Our File: 9506

January 14, 2014

**Re: Response to Burnside Review of Hydrogeological Summary
Report Hidden Quarry Site for Township of Guelph/Eramosa
Burnside File No.: 300032475.0000**

Figure 1:
Environmental Features Well 4

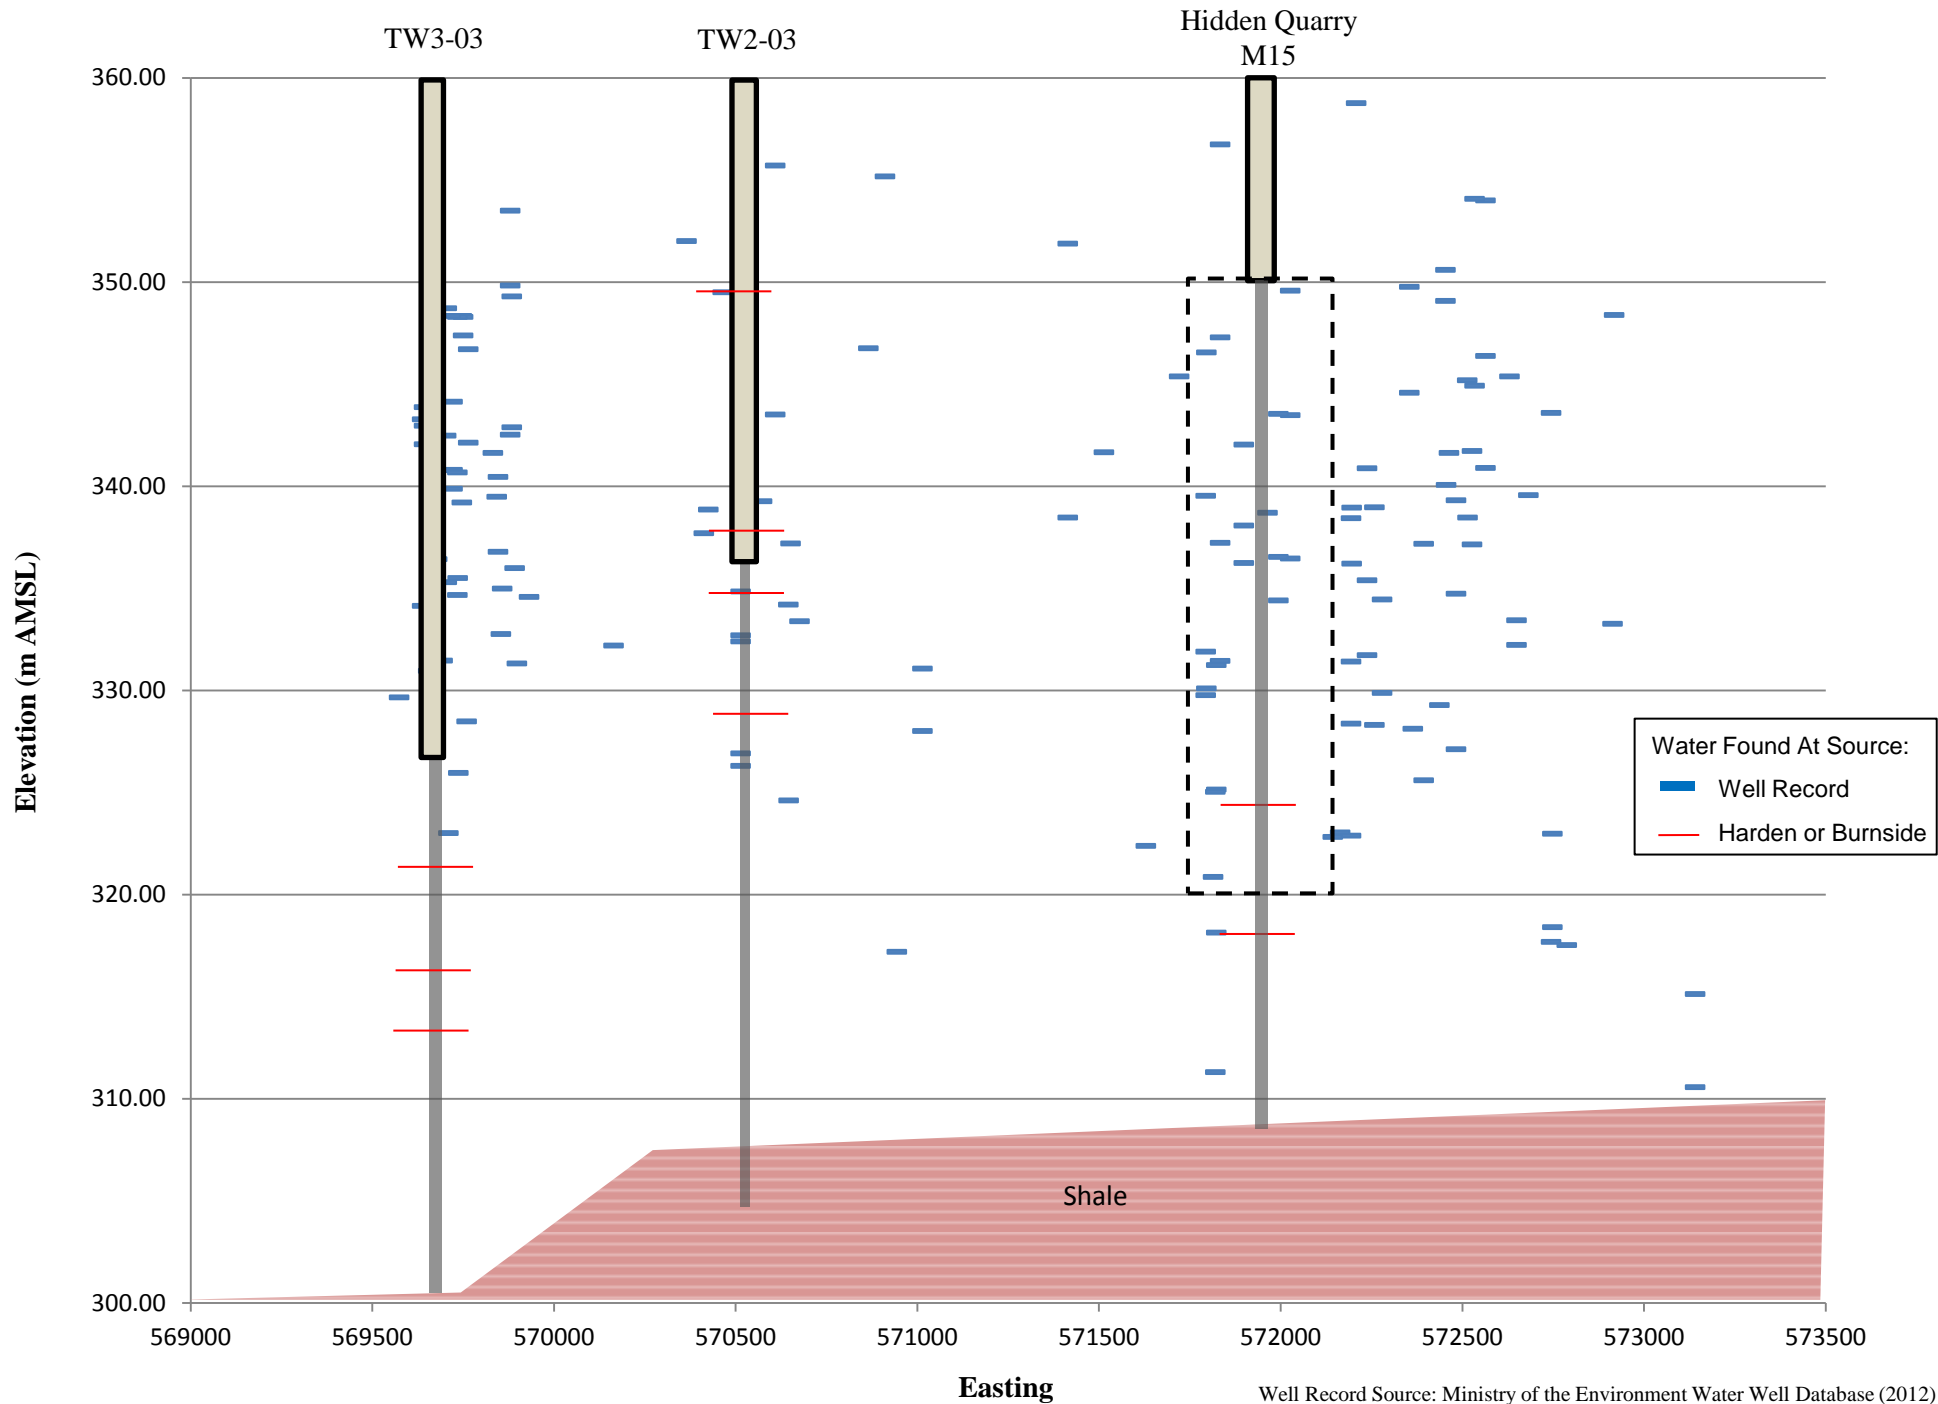
We disagree that the quarry may result in the classification of the future Well No. 4 as Groundwater Under the Direct Influence of Surface Water (GUDI).

This rule already applies given that Tributary A and associated wetlands are within 500 metres of Well No. 4 (Figure 1). Tributary A is a perennial stream that loses water between Eramosa Line 6 and Hwy 7 part of which falls within 500 metres of Well No. 4. This will flag the well as potentially GUDI and appropriate chemical and physical testing will be required to determine if the well is indeed GUDI or not.

Figure 4:
Downgradient Private Wells

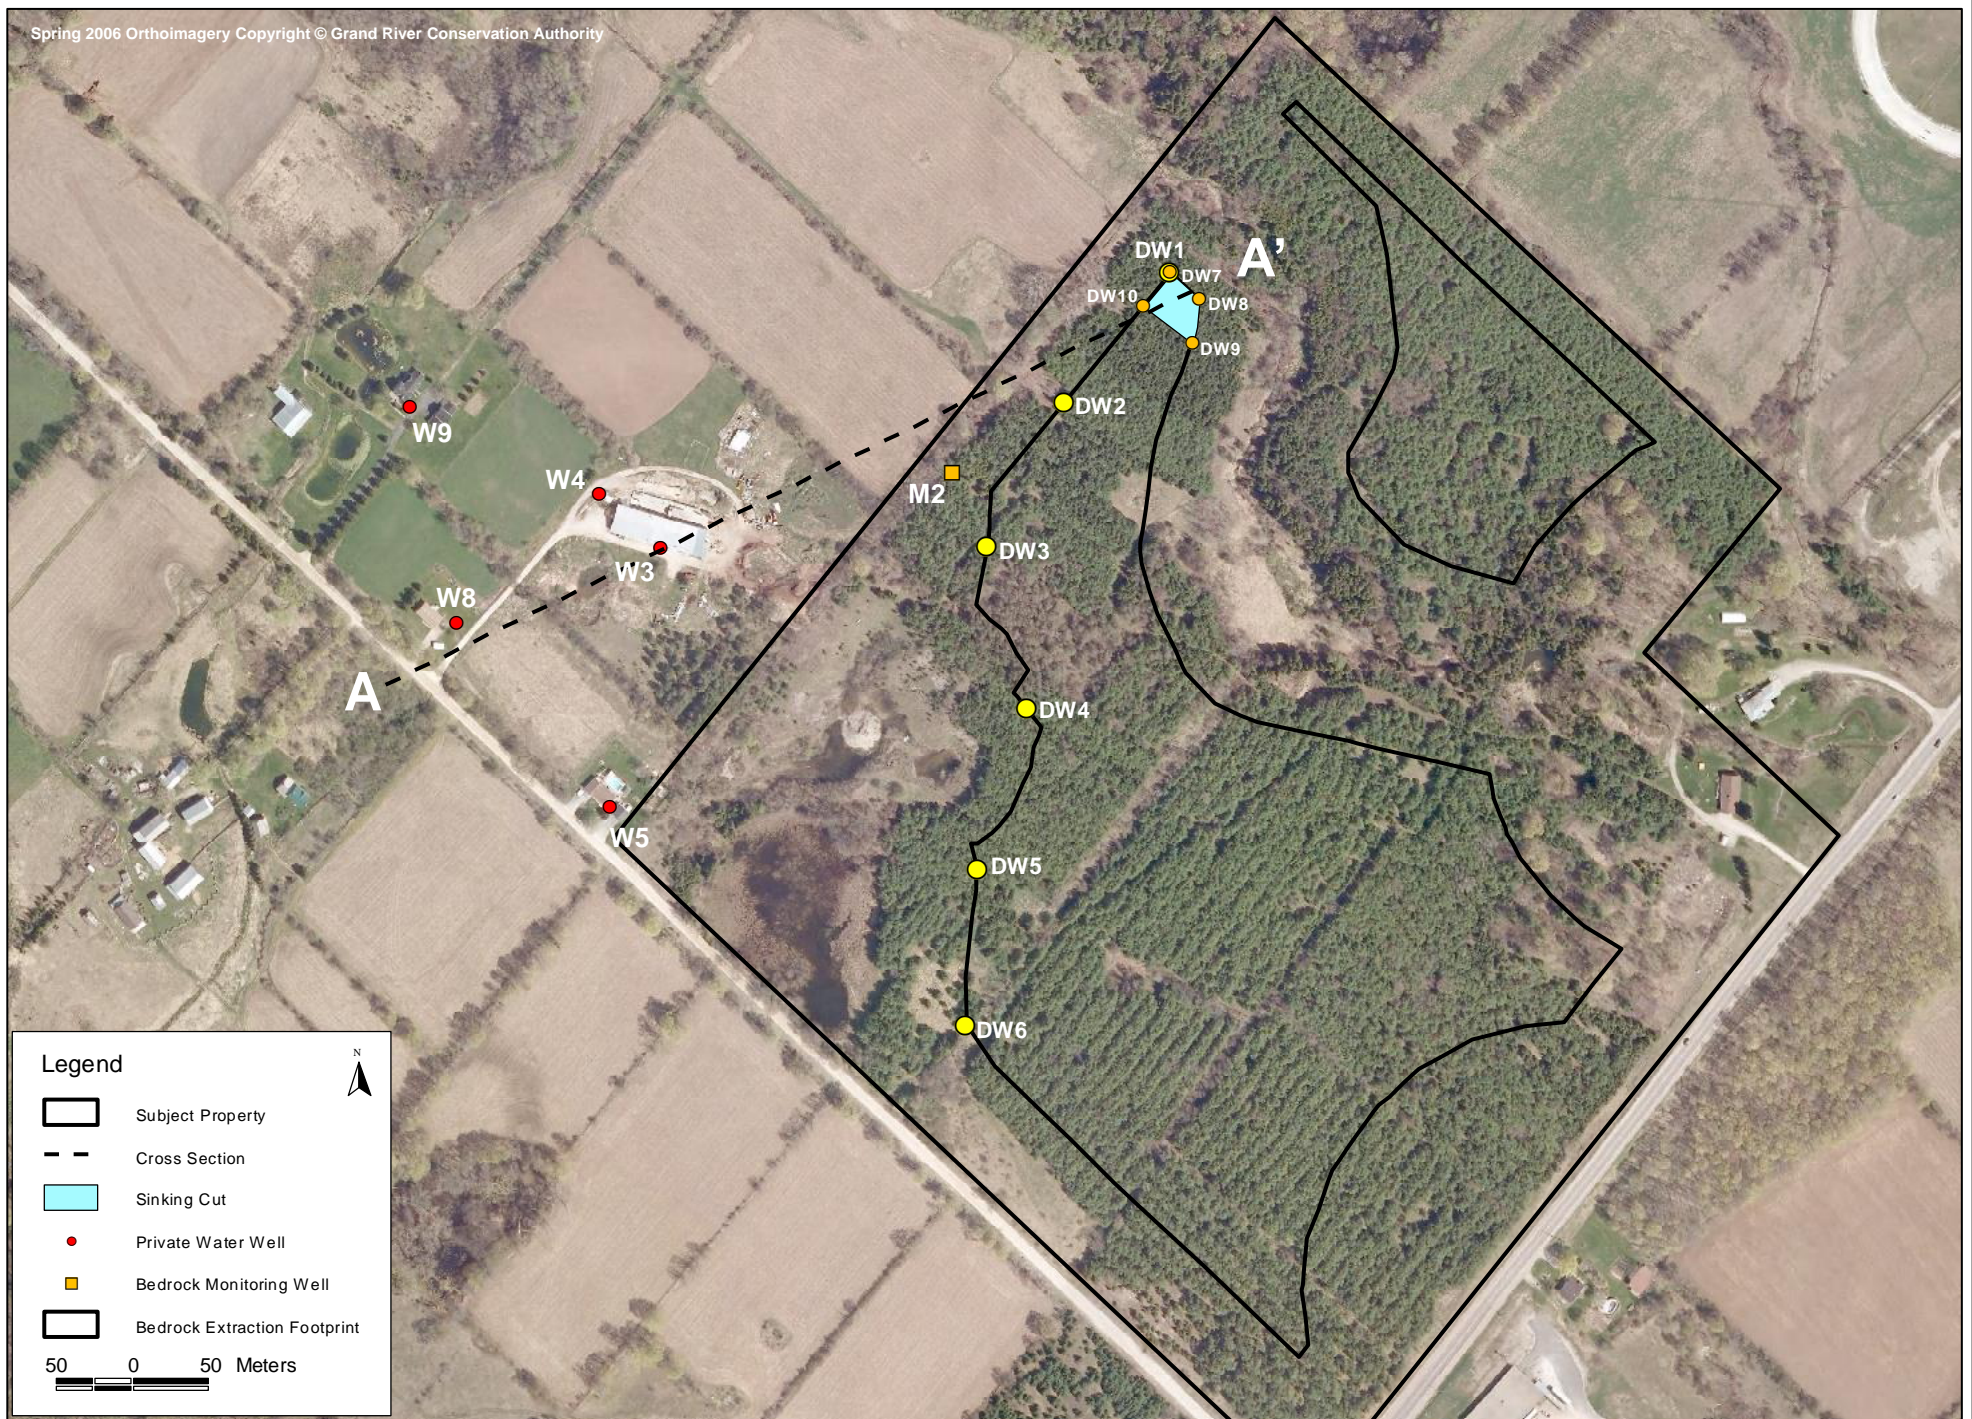
Pathogen Movement

Figure 4 shows the wells that are downgradient of the quarry. These are the only wells that have any risk of water quality impacts. It is our opinion that the detailed monitoring program will identify chemical and bacteriological movement from the quarry and contingency measures are in place in the event that a local well is impacted. Recent testing of the Guelph Limestone quarry during blasting found that the water met all Ontario Drinking Water Quality Standards for comprehensive suite of parameters.

Figure 6: Cross Section A-A' Key Map

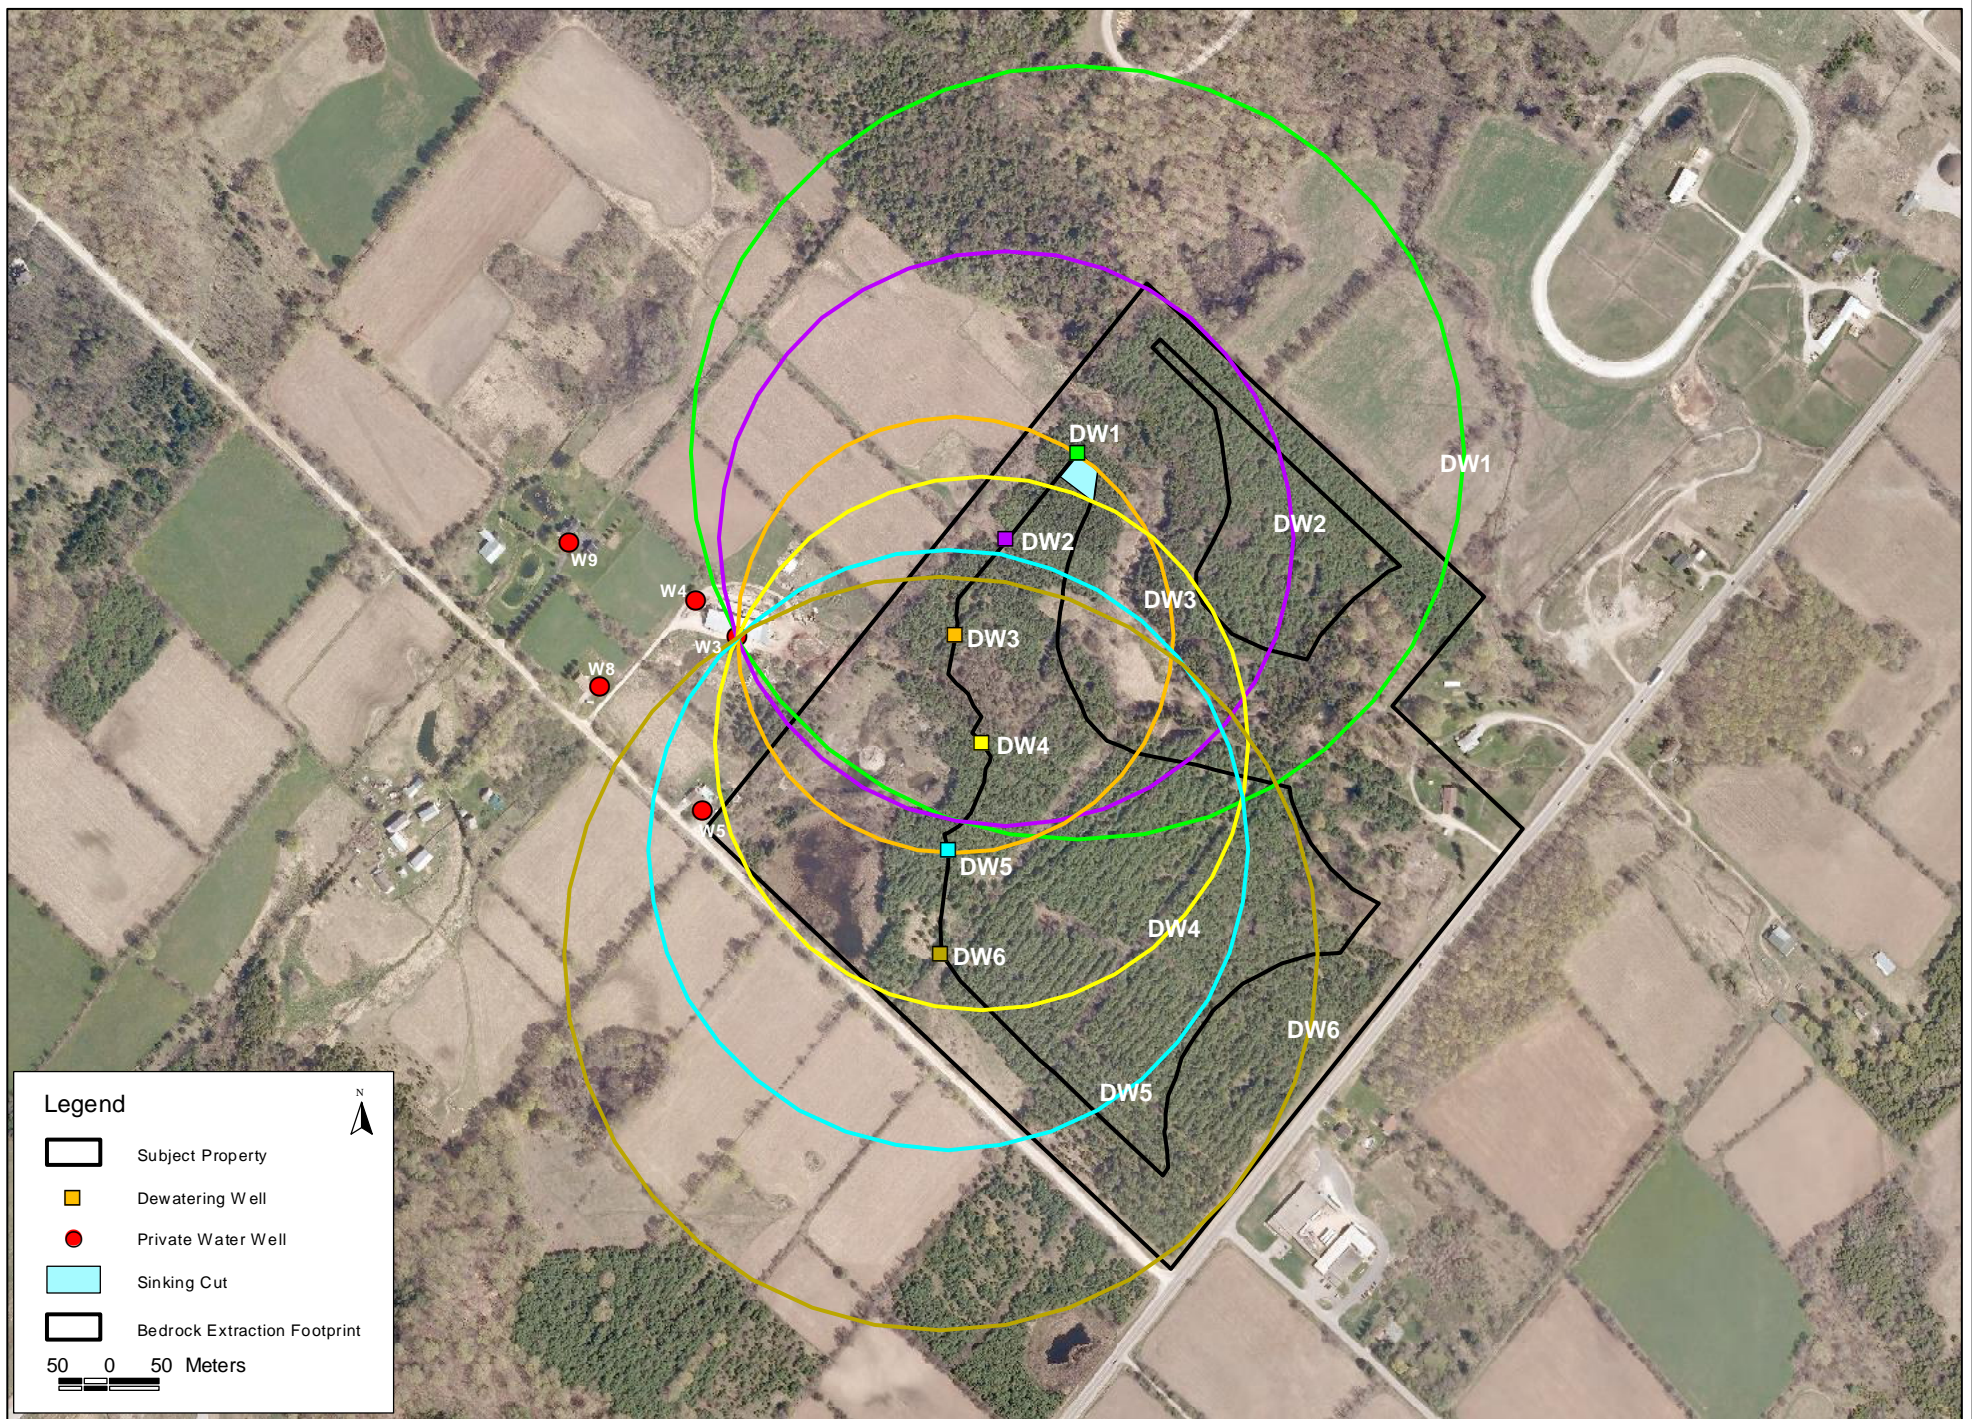
We agree that a reconstructed M15 will provide improved characterization of individual fracture sets. It is our opinion that this knowledge will not materially affect the predictions of drawdown in neighbouring wells.

In order to corroborate the model results using traditional well hydraulic methods, we have simulated the extraction process by using a series of dewatering wells. Figure 6 shows the location of the dewatering wells used in the simulation. The theory of superposition is that the impact of each dewatering well is additive. Therefore, as depicted in Figure 7, the anticipated drawdown at private well W3 is determined as follows;

In order to estimate the magnitude of impact at the nearest five private wells shown on Figure 6, we have calculated the cumulative drawdown from each of the six dewatering wells (DW1-DW6) at each private well. The drawdown is estimated using the modified equilibrium equation (Cooper and Jacob, 1946);
